Access Compliance Report Public Rights-of-Way (RR Crossings)

Intersection ID: 13985	Main Street: CAMDEN_RD	Location: N/A
ADA ID: C0EE6DEB5630	Overall Compliance: No	Severity Score: 0.0
Codes/Mitigation Info/Possible Solution		Field Measurements/Component Compliance

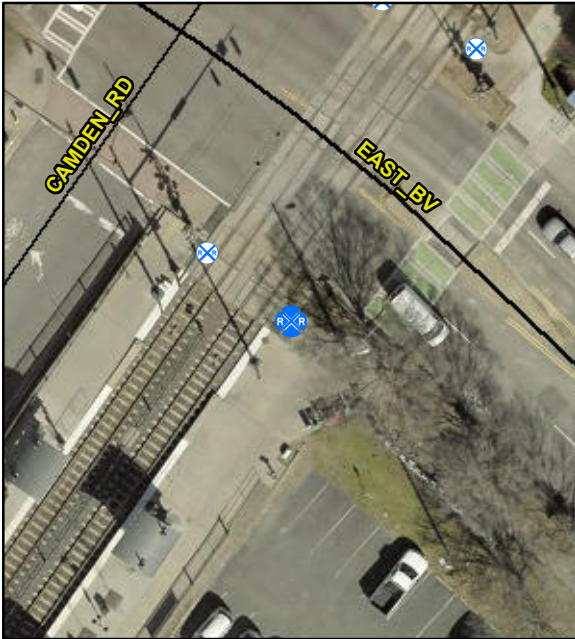
Compliance	Description	Data
Yes	DWS Provided?	Yes
Yes	DWS Contrast?	Yes
Yes	DWS Width (in)	Yes
Yes	DWS Length (in)	36.0
No	DWS Offset (in)	18.0
No	Pedestrian Gate?	No
N/A	DWS Outside Gate?	No
N/A	Rail Type?	LightRail
No	Flangeway Gap (in)	3.0
Yes	Sidewalk Width (in)	99.0

**Remove & Replace Detectable
Warning System. Provide Pedestrian
Gate. Remove & Replace Walking
Surface Adjacent to Rail.**
